Determination 2016/061

Regarding aluminium window and door joinery installed to a house at 128 Fordyce Road, Helensville

Summary

Figure 1: Changes in window details

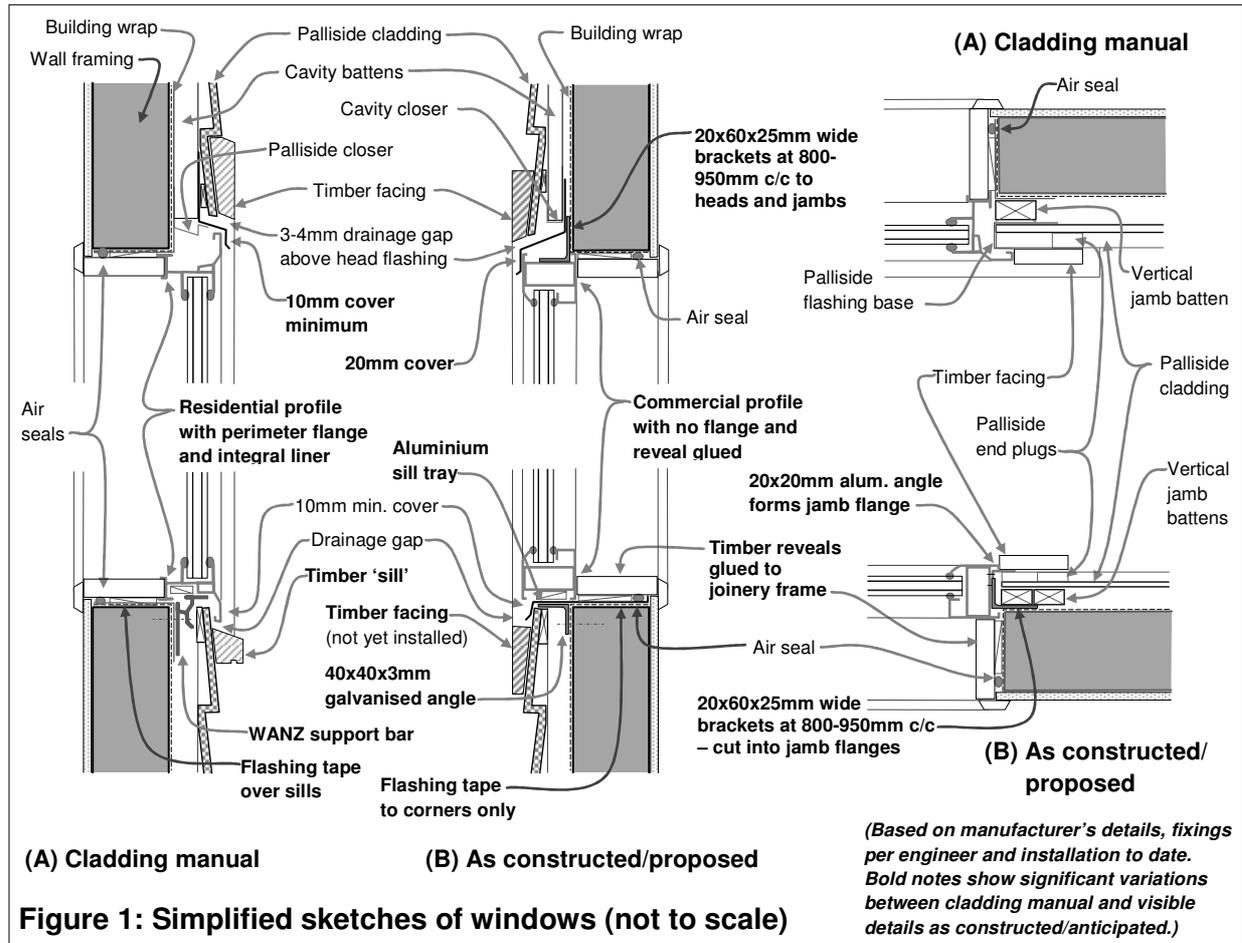
2.4.4 As shown in Figure 1, significant changes include the following:

(A) Cladding manufacturer's details	(B) The imported joinery	
		Amendment details	As constructed
Joinery profile	Conventional <u>residential</u> profiles (<u>integrated reveals</u>) Full perimeter flange	Light <u>commercial</u> profile, with primary box frame (<u>no integrated reveals</u>) <u>50x50mm</u> aluminium angle riveted to window frame to form jamb flange	<u>20x20mm</u> aluminium angle forms jamb flange
Support	WANZ ⁷ sill support bar shown	WANZ sill support bar not shown <u>50x50x6mm galvanised brackets</u> noted – but no spacing specified.	<u>Continuous 40x40x3mm</u> galvanised angle installed under sills
Framing	Flexible flashing tape noted as continuous over sill	Flexible flashing tape noted as <u>continuous over sill</u>	Flexible flashing tape applied over wrap at <u>corners</u> of openings
Flashing	No sill flashings shown	No sill flashings shown	<u>Coated aluminium sill trays</u> visible where reveals not yet installed.

(A) Cladding manufacturer's details	(B) The imported joinery	
		Amendment details	As constructed
Fixing	Engineer's PS1 covered	<p>Bowmac brackets shown at jambs only, with no size, spacing or fixings.</p> <p>Engineer's site note states:</p> <ul style="list-style-type: none"> • 20x60x1 mm brackets <u>generally at 800mm c/c, fixed with 4 screws.</u> • Frame glued to reveal. Reveal screwed to timber framing. <p>Timber reveals cut to suit following window installation</p> <ul style="list-style-type: none"> • No note of reveal fixings • No sealant shown at junction 	<p>20x60x25mm wide galvanised steel brackets at <u>800mm to 950mm c/c</u>, fixed to framing with <u>2 screws</u> into framing.</p> <p>Aluminium angle flange cut to allow screw fixing of bracket to window frame.</p> <p>Timber reveals not yet installed</p>

5.4.1 The expert noted the following changes in window installation between the details supplied for the proposed consent amendment and the consent details (see Figure 1):

- for the partially installed/proposed joinery installation compared to E2/AS1 and the cladding manufacturer's details (see Figure 1):
 - riveted and sealed flanges added to jamb provide similar overlaps

- head flashings provide at least the same minimum overlap
 - the installed aluminium sill tray flashings will allow any moisture penetrating the air seals to drain to the outside rather than down the cavity, so the proposal should improve expected performance

- the proposed timber facing boards are decorative and unlikely to have any significant effect on weathertightness
 - the use of galvanised angles in lieu of WANZ sill support bars is covered by the engineer's producer statement.

- Although required weathertightness tests have not yet been completed, I concur with the expert’s opinion that a modification of the testing procedures proposed by the testing company followed by an appropriate report of successful tests would provide evidence of adequate weathertightness of the joinery.

- 7.1 In accordance with section 188 of the Building Act 2004, I hereby determine that there is currently insufficient evidence to establish on reasonable grounds that the imported joinery will comply with Clause E2 of the Building Code, and accordingly I confirm the authority's decision to refuse to amend the building consent, in respect of that matter only.
